DEEP INJECTION WELL PUMP STATION

CITY OF HIALEAH, FLORIDA

AS-BUILT - FOR OPERATIONAL TESTING

REVISION 2 - CONFORMED SET NOTES (#)

PROPOSED 7.39-MGD DEEP INJECTION WELL PUMP STATION SITE PLAN

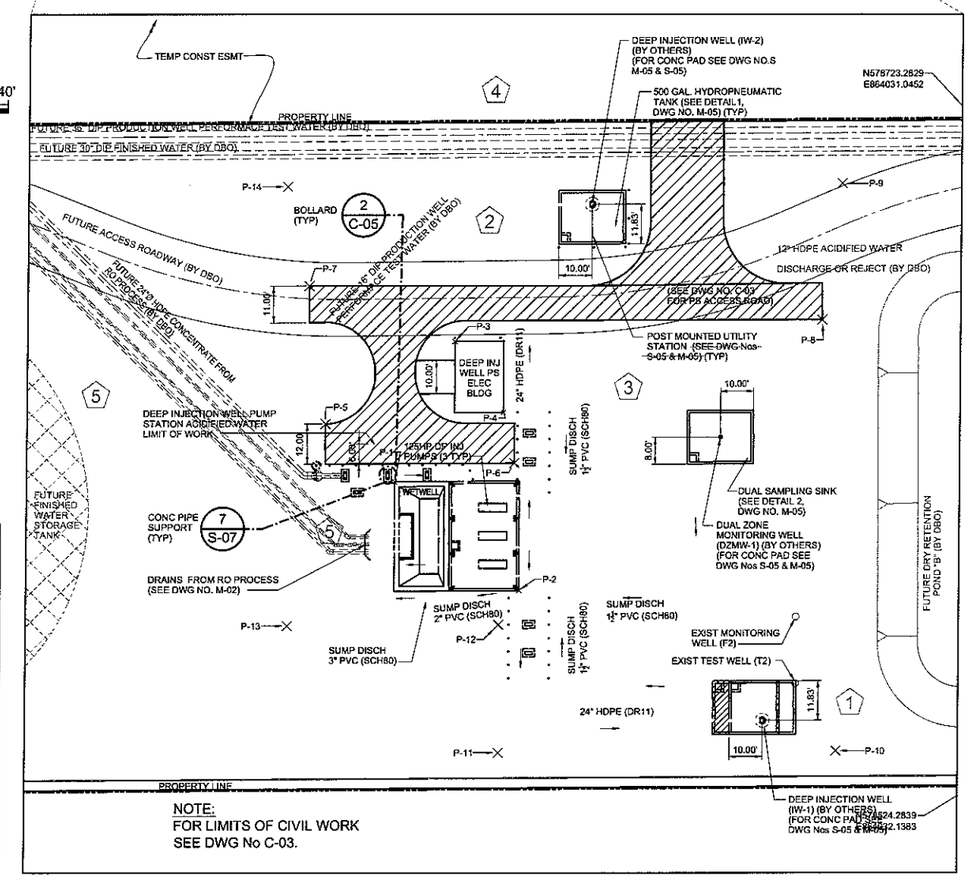
1. CONTRACTOR SHALL PROVIDE BAHIA SOD WITHIN THE LIMITS OF CONSTRUCTION. CONTRACTOR SHALL MAINTAIN AND WARRANT THE SOD FOR A MINIMUM OF 3 MONTHS. SOD SHALL BE KEPT IN A HEALTHY CONDITION THROUGHOUT THE WARRANTY PERIOD.
2. THIS PIPE SHALL BE INSTALLED WITH A MINIMUM 6 FEET COVER.
3. POST MOUNTED UTILITY STATION DETAILS (SEE DETAILS 5 & 7 ON SHEET C-05). THE DBO CONTRACTOR (TO BE PROCURED BY OWNER) WILL INSTALL AND CONNECT THE POTABLE WATER LINES (TYP 3). DBO CONTRACTOR SHALL PROVIDE THE HOSE.
4. THE LABELED LINE ["FUTURE 16" DIP PRODUCTION WELL PERFORMANCE TEST WATER (BY DBO)"] HAS BEEN REMOVED FROM THIS PROJECT.
5. THE DWIPS CONTRACTOR SHALL INSTALL THE 10" ACIDIFIED DISCHARGE OR REJECT LINE FROM THE DWIPS WET WELL TO 6'-0" FROM EDGE OF ROAD BASE.

CIVIL
YARD PIPING PLAN & DETAILS

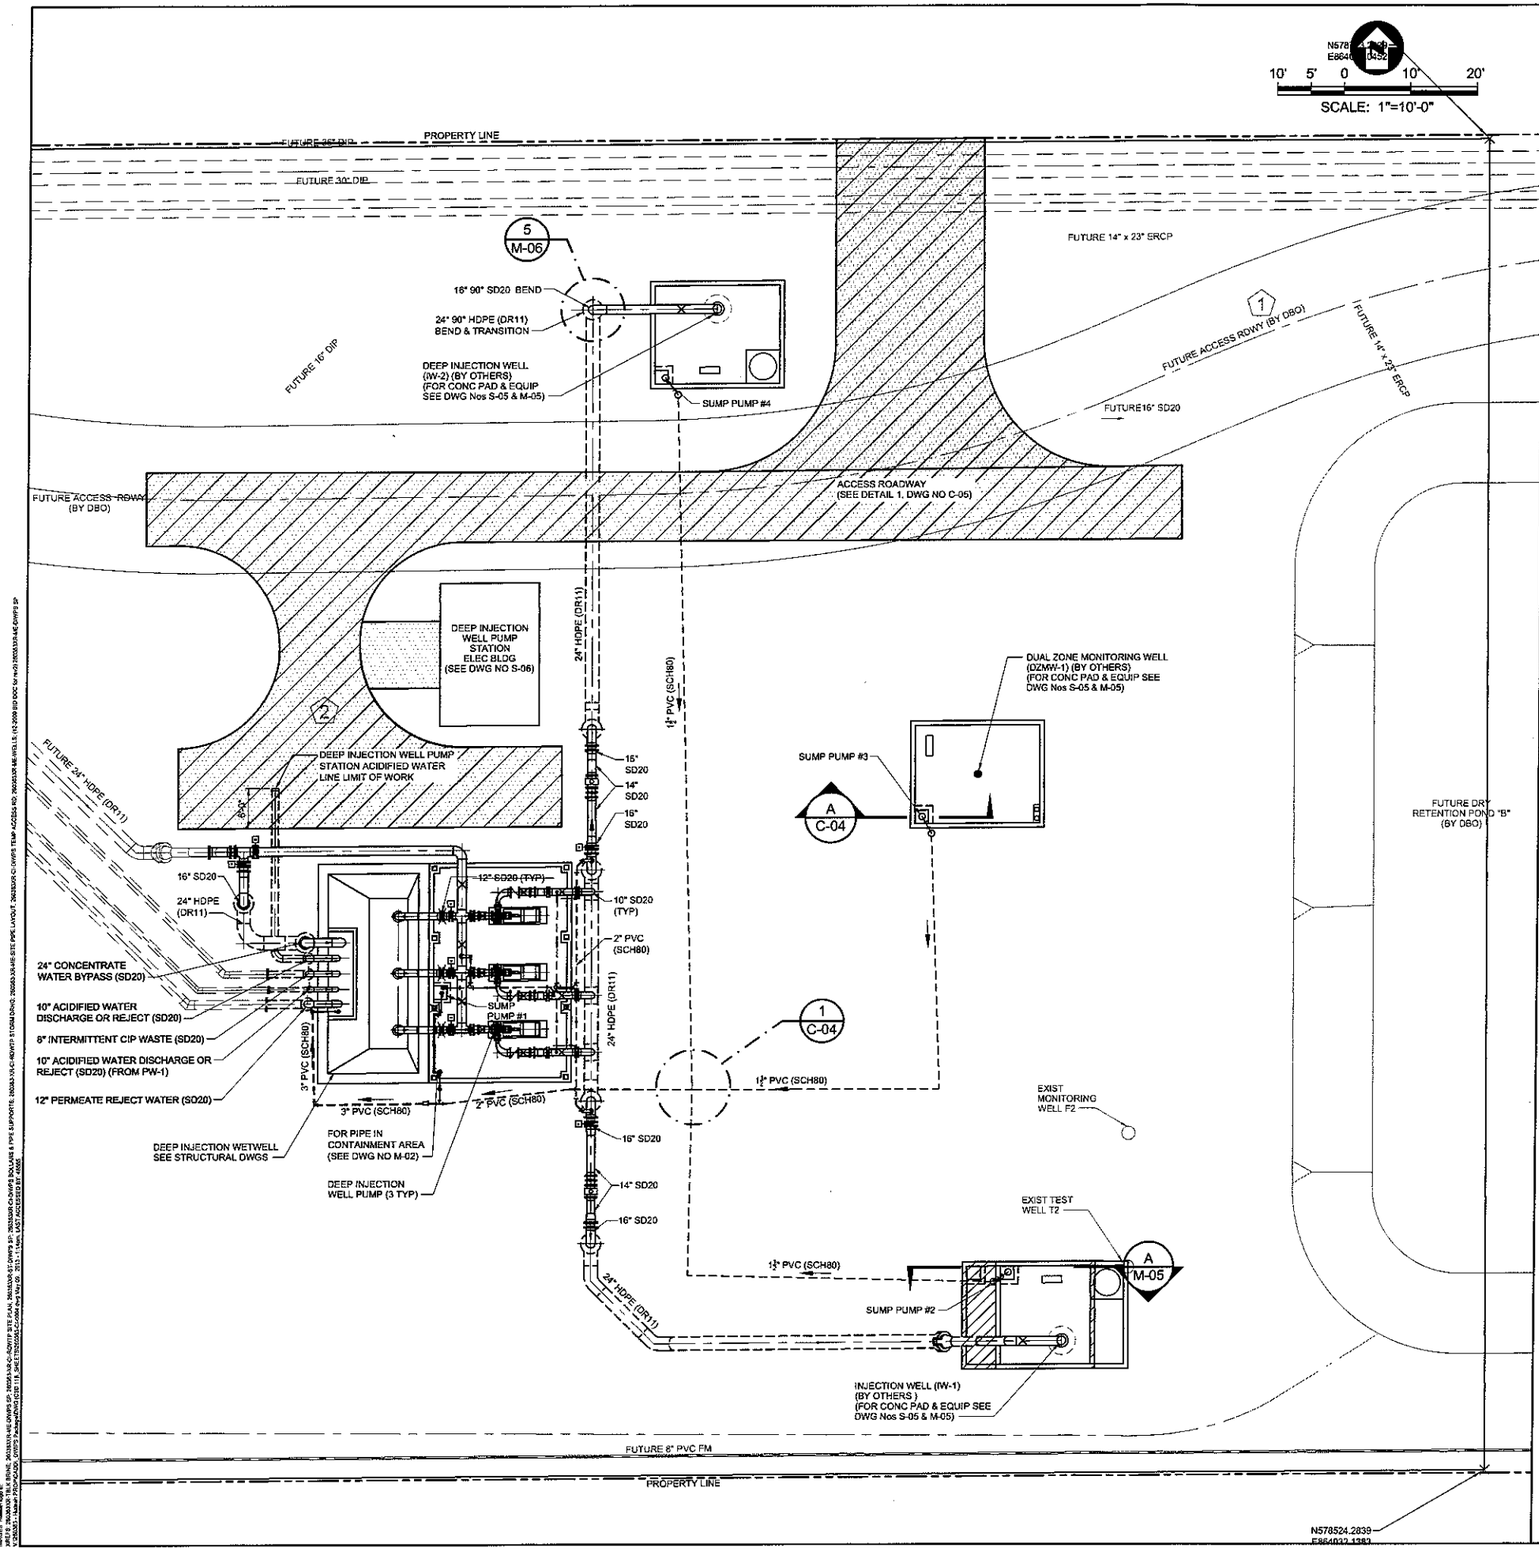
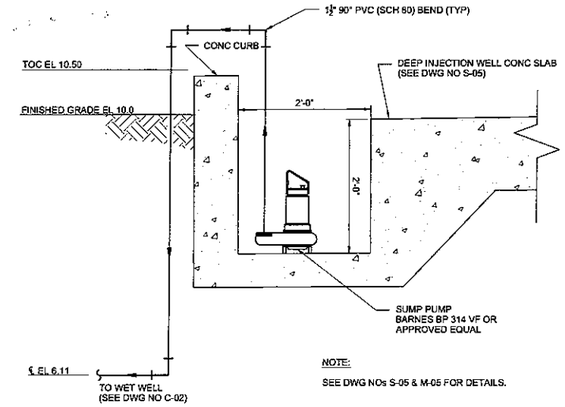
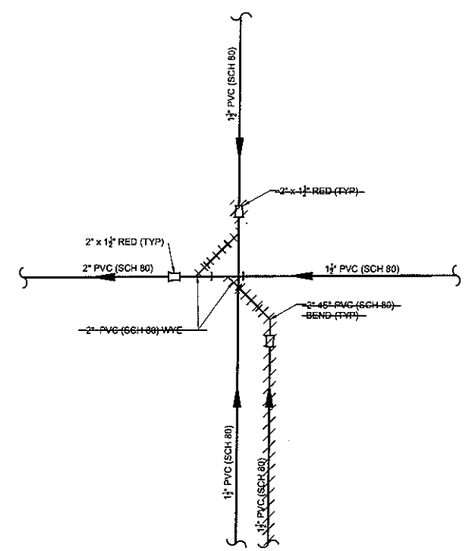
1. CONTRACTOR SHALL PROVIDE BAHIA SOD WITHIN THE LIMITS OF CONSTRUCTION. CONTRACTOR SHALL MAINTAIN AND WARRANT THE SOD FOR A MINIMUM OF 3 MONTHS. SOD SHALL BE KEPT IN A HEALTHY CONDITION THROUGHOUT THE WARRANTY PERIOD.
2. THE DWIPS CONTRACTOR SHALL INSTALL THE 10" ACIDIFIED DISCHARGE OR REJECT LINE FROM THE DWIPS WET WELL TO 6'-0" FROM EDGE OF ROAD BASE.

1 M-02 PLAN
SCALE: 1/4" = 1'-0"

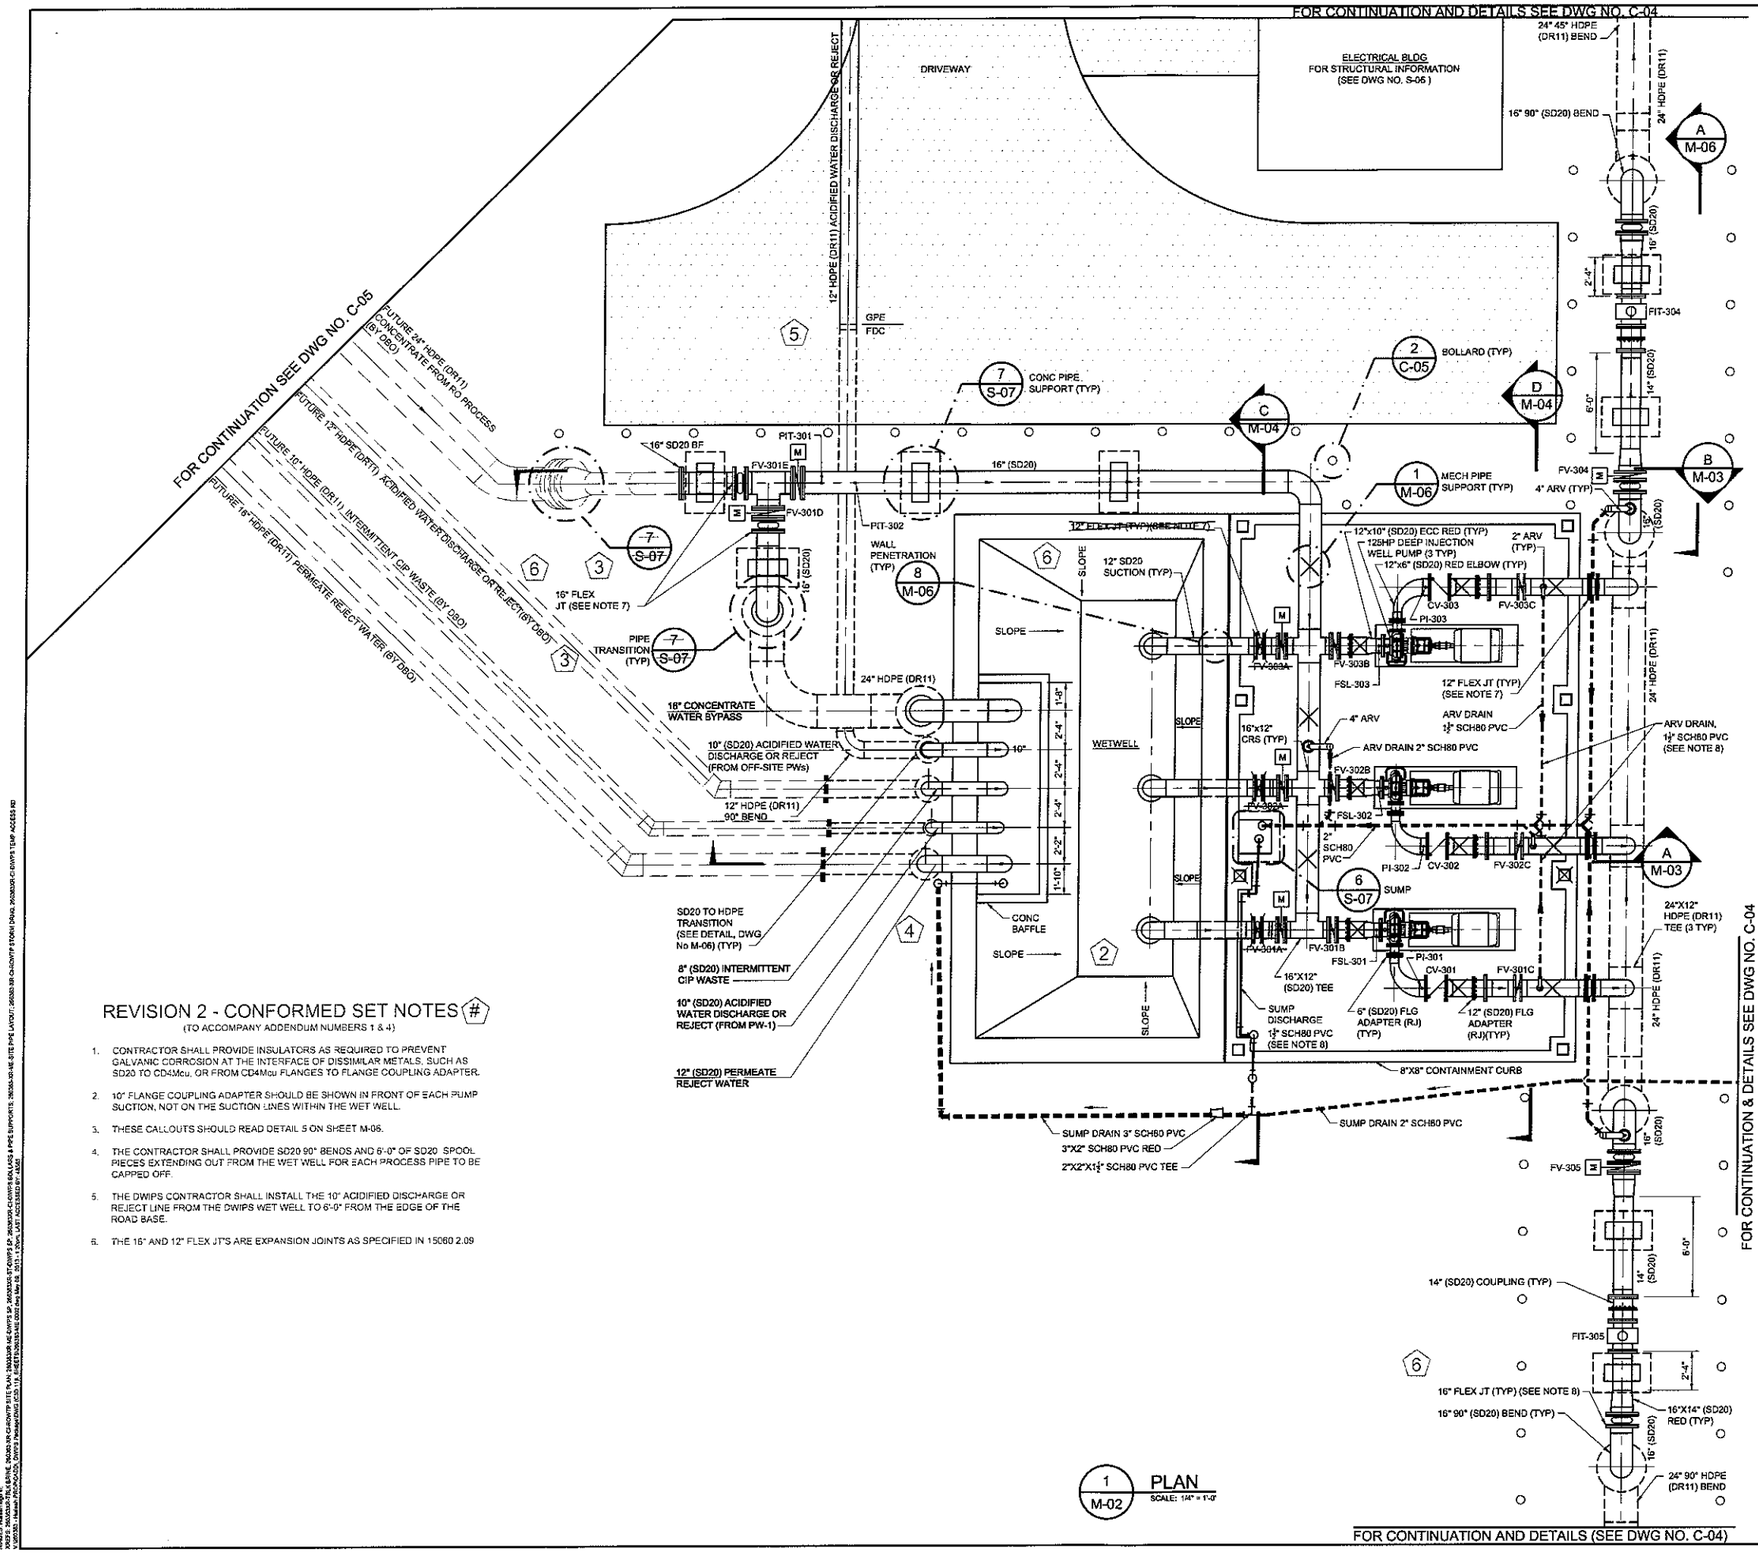
1. CONTRACTOR SHALL PROVIDE INSULATORS AS REQUIRED TO PREVENT GALVANIC CORROSION AT THE INTERFACE OF DISSIMILAR METALS, SUCH AS SD20 TO CD4Mcu, OR FROM CD4Mcu FLANGES TO FLANGE COUPLING ADAPTER.
2. 10" FLANGE COUPLING ADAPTER SHOULD BE SHOWN IN FRONT OF EACH PUMP SUCTION, NOT ON THE SUCTION LINES WITHIN THE WET WELL.
3. THESE CALLOUTS SHOULD READ DETAIL 5 ON SHEET M-06.
4. THE CONTRACTOR SHALL PROVIDE SD20 90° BENDS AND 6'-0" OF SD20 SPOOL PIECES EXTENDING OUT FROM THE WET WELL FOR EACH PROCESS PIPE TO BE CAPPED OFF.
5. THE DWIPS CONTRACTOR SHALL INSTALL THE 10" ACIDIFIED DISCHARGE OR REJECT LINE FROM THE DWIPS WET WELL TO 6'-0" FROM THE EDGE OF THE ROAD BASE.
6. THE 16" AND 12" FLEX JT'S ARE EXPANSION JOINTS AS SPECIFIED IN 15060 2.09
